Project
BARANGAROO STAGE 1B
PUBLIC DOMAIN
Modification S4.55

Drawing Title
HICKSON PARK SOUTH
ENTRY DETAIL PLAN - NO
TREES
Drawn
SS

Drawing Number
BAR-418-DA-HP-DP04
Checked
MW

Drawing Title
HICKSON PARK SECTION
J-J

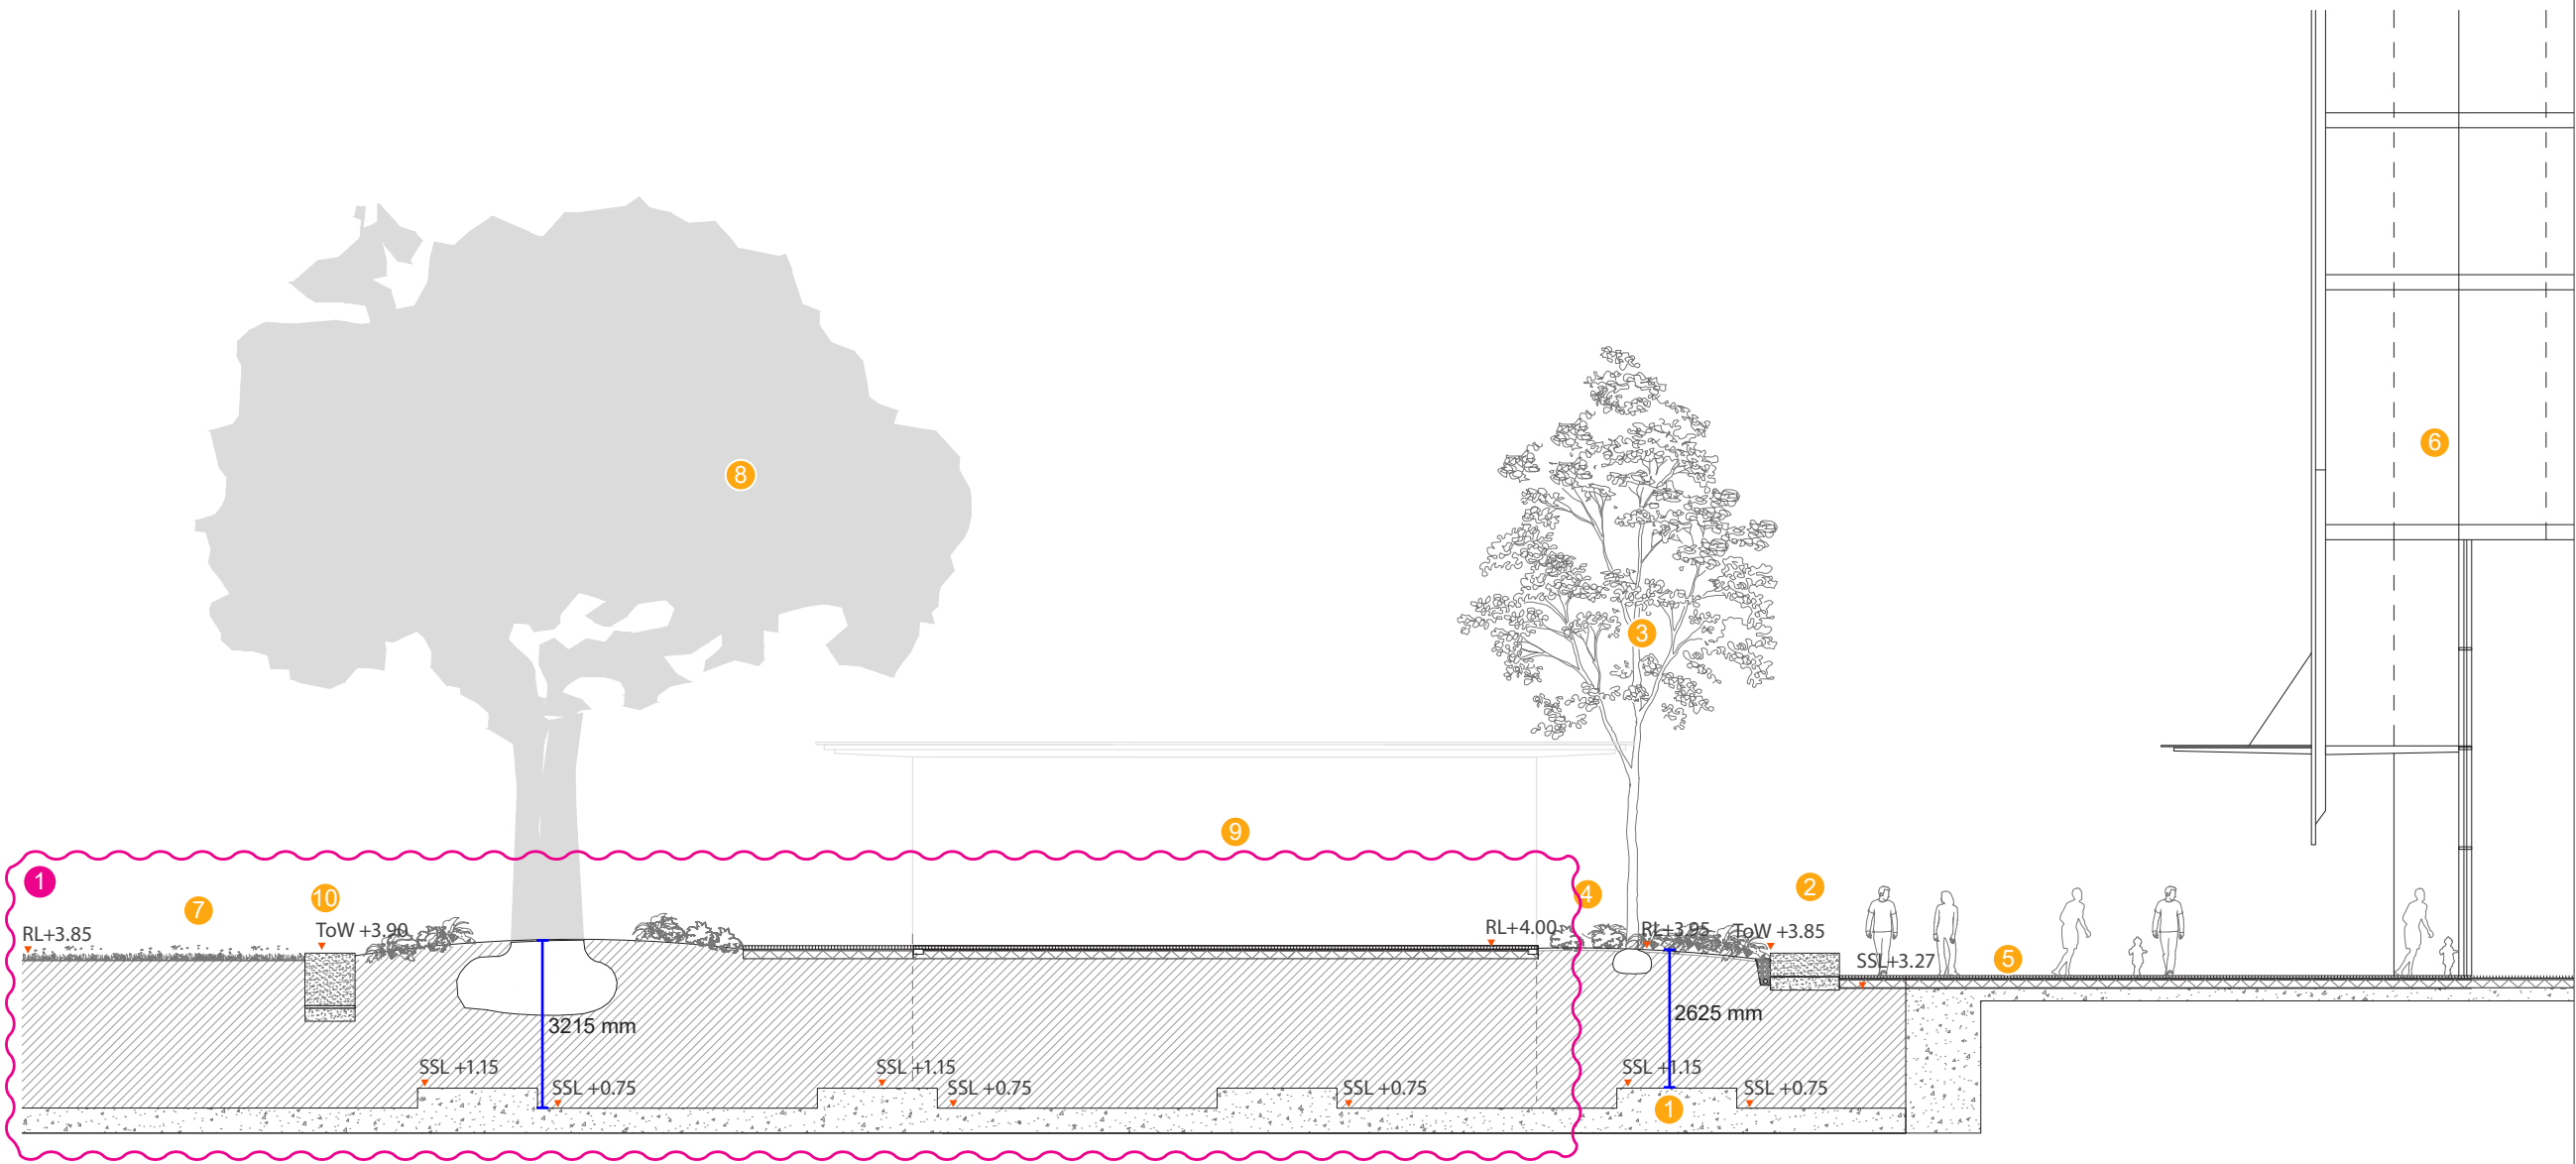
- Proposed Modifications**
- Amendment cloud
 - 1 Levels changed due to proposed Hickson Road levels

Drawing Title
HICKSON PARK SECTION
K-K

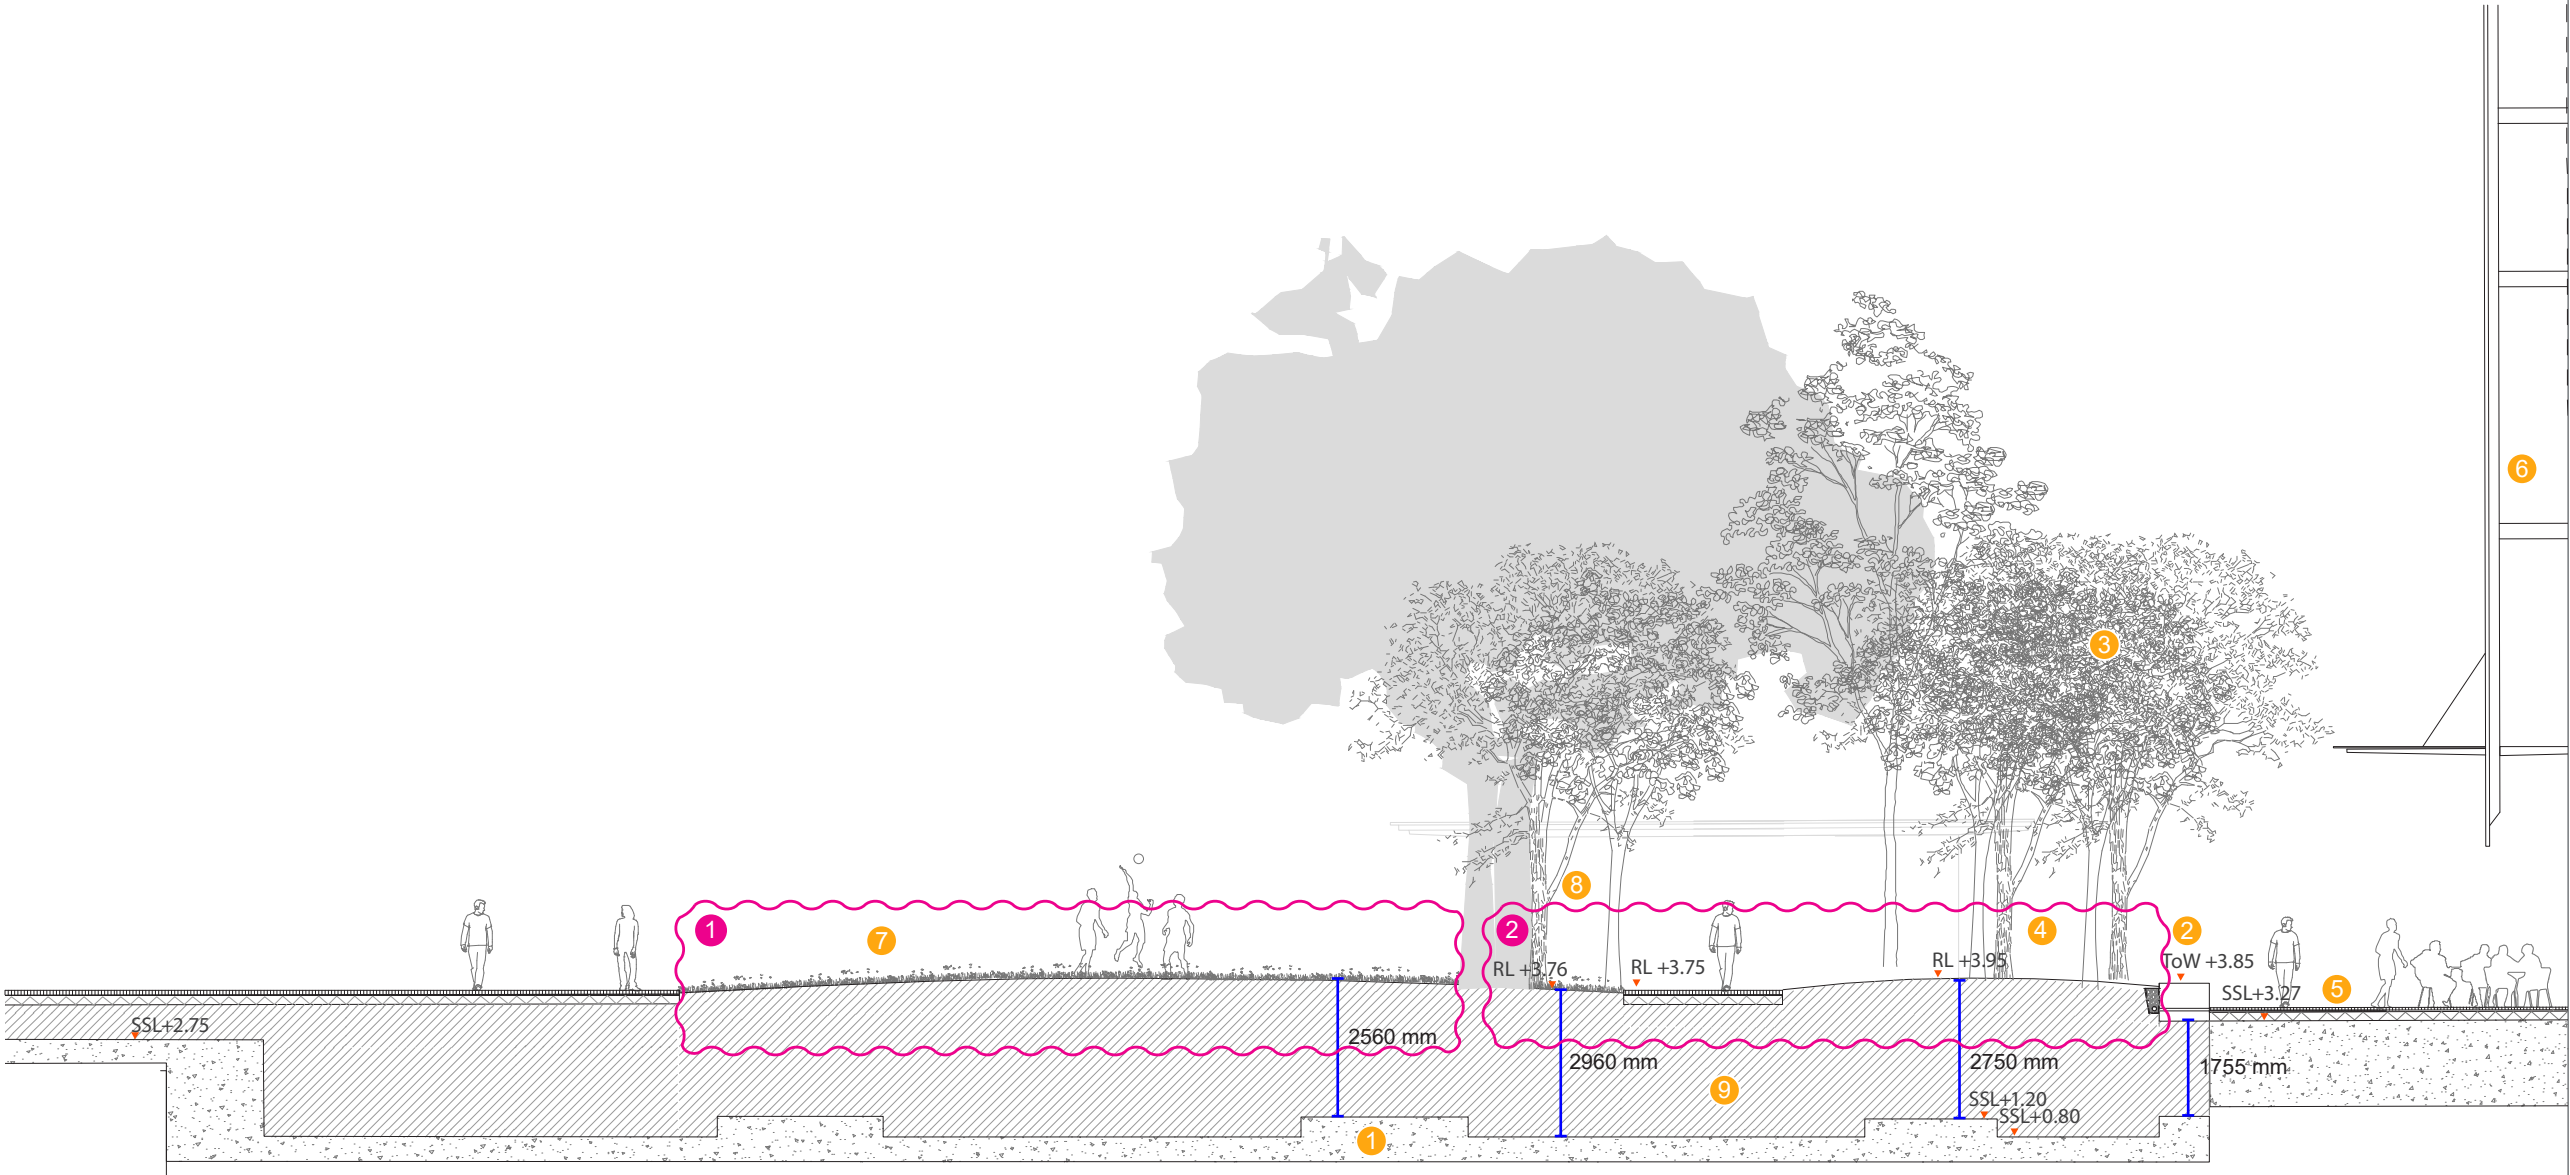
- 1 Levels changed due to proposed Hickson Road levels
- 2 Increase planting area within the park and change of geometry.

Drawing Title
**WULUGUL WALK & SPIRIT OF
TASMANIA LOADING DOCK
DETAIL PLAN - NO TREES**
Drawn
SS

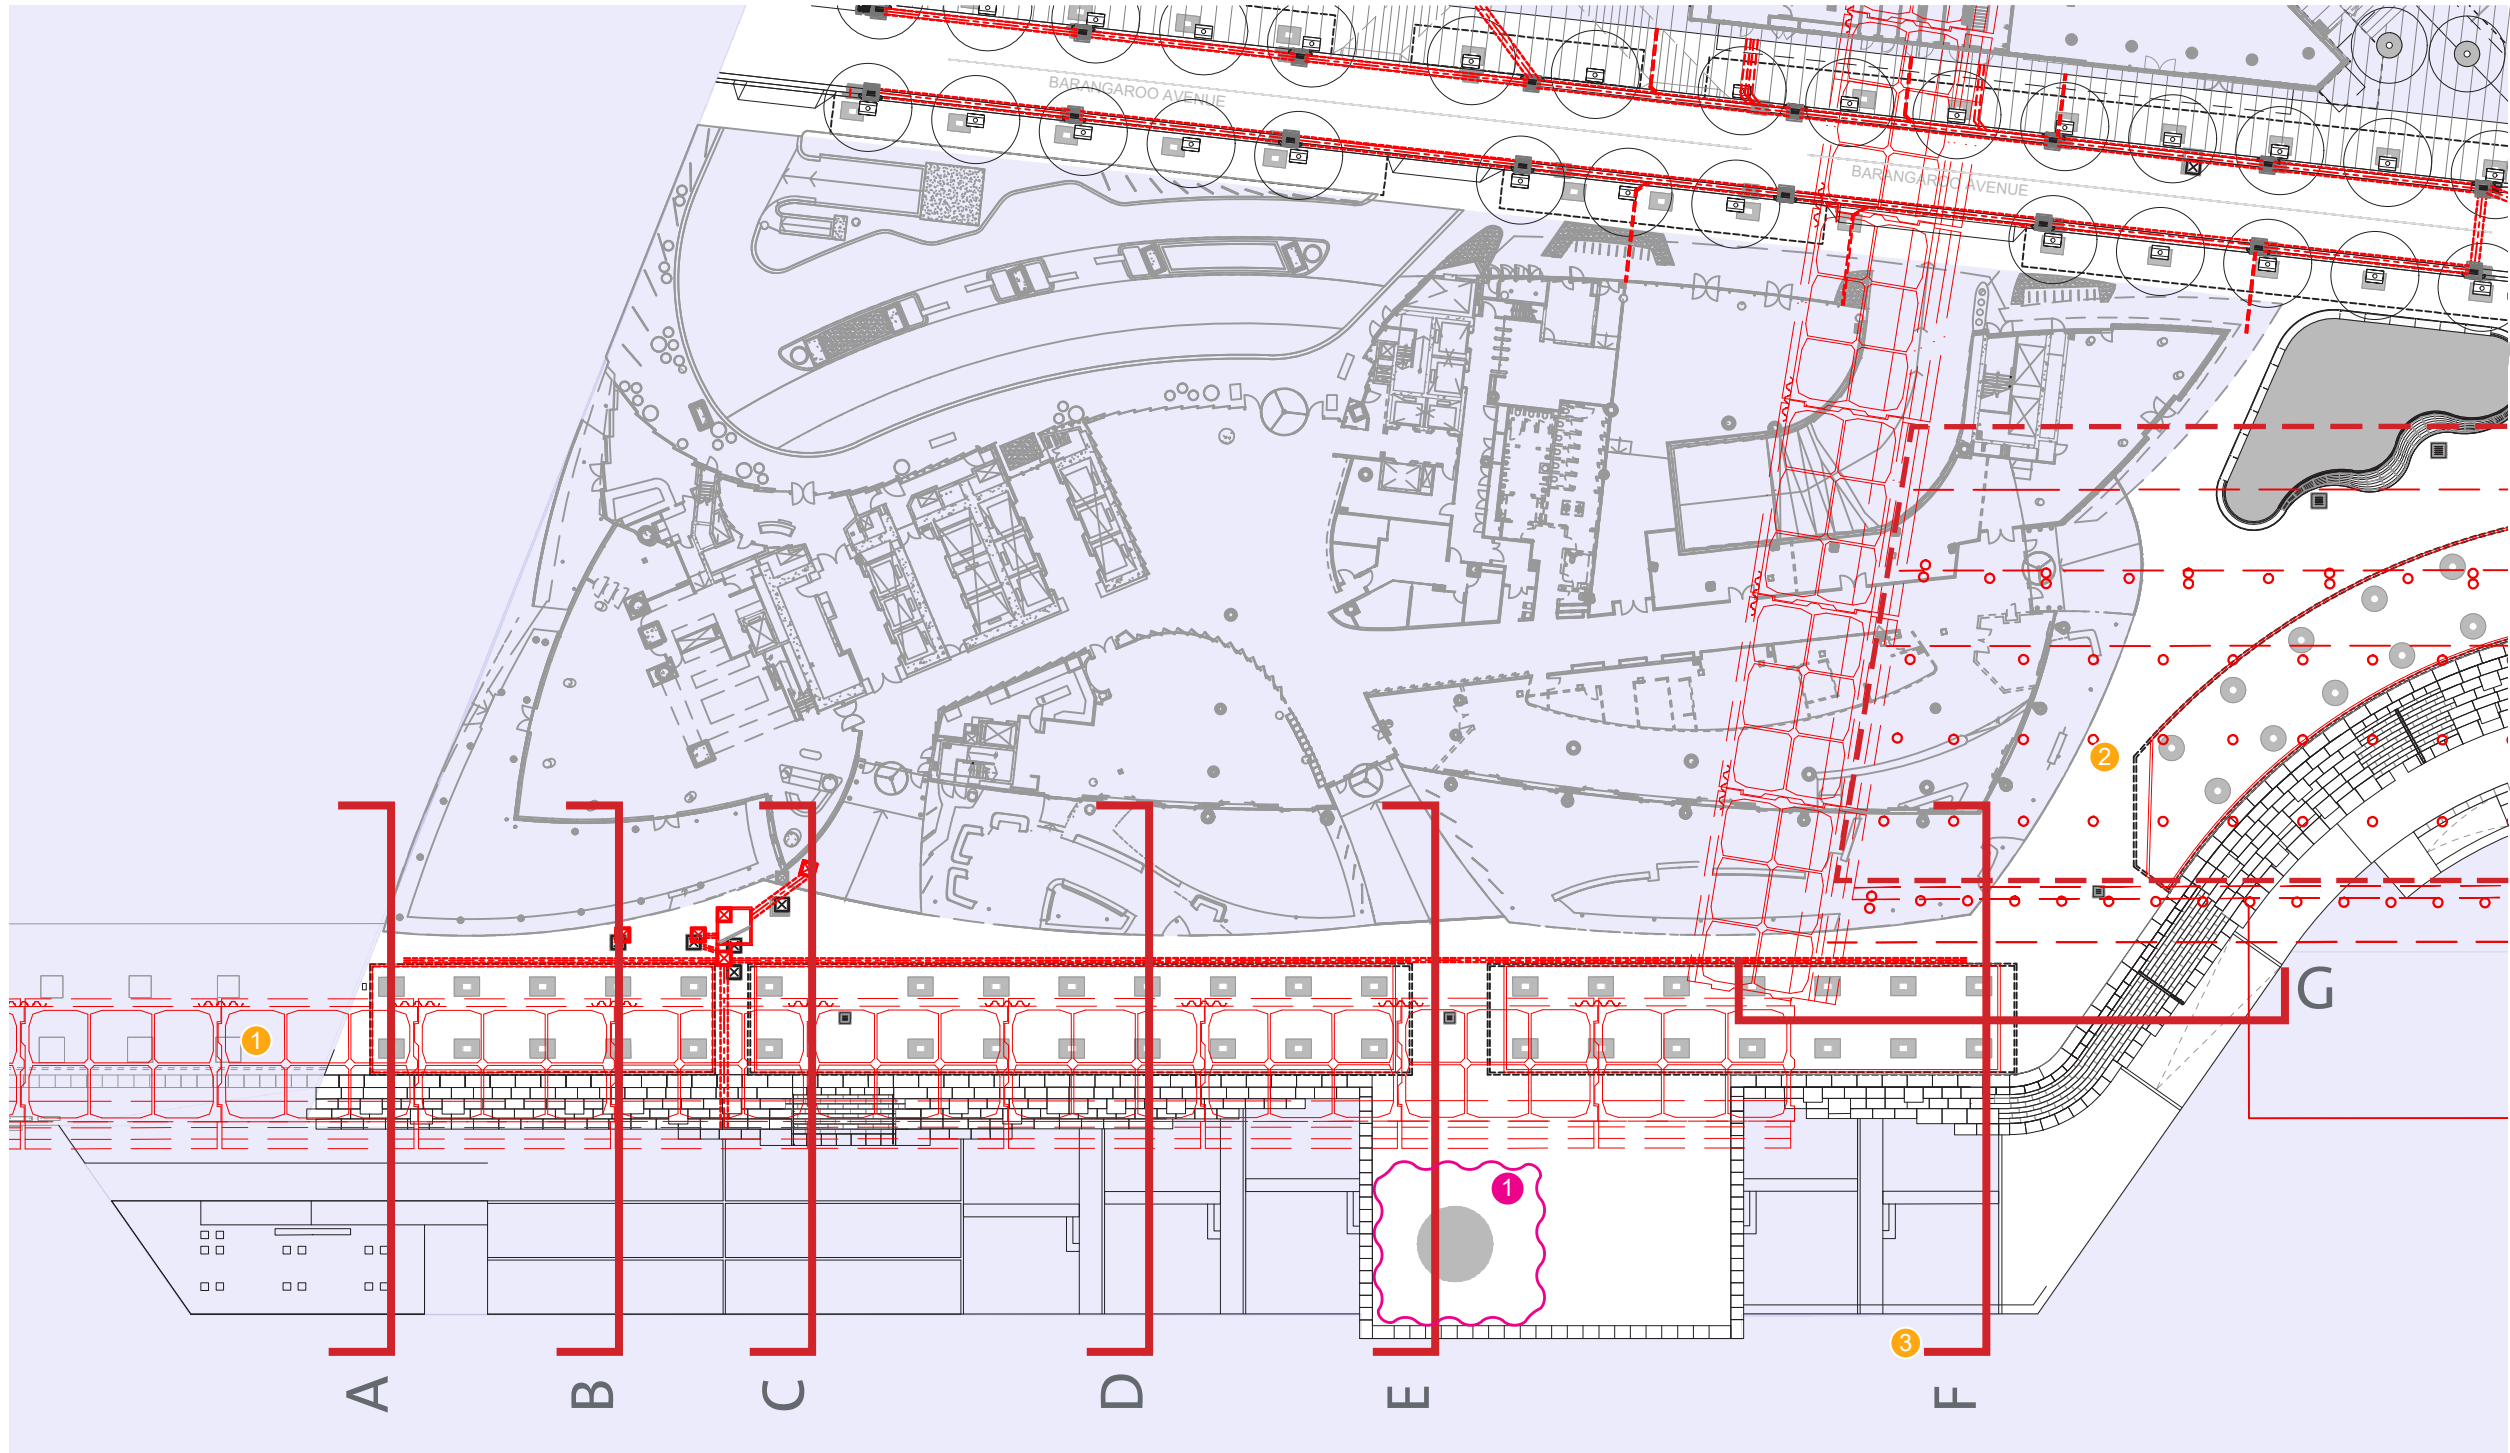
- Amendment cloud
- 1 Remove timber top for Sprit of Tasmania loading dock raised planter seating
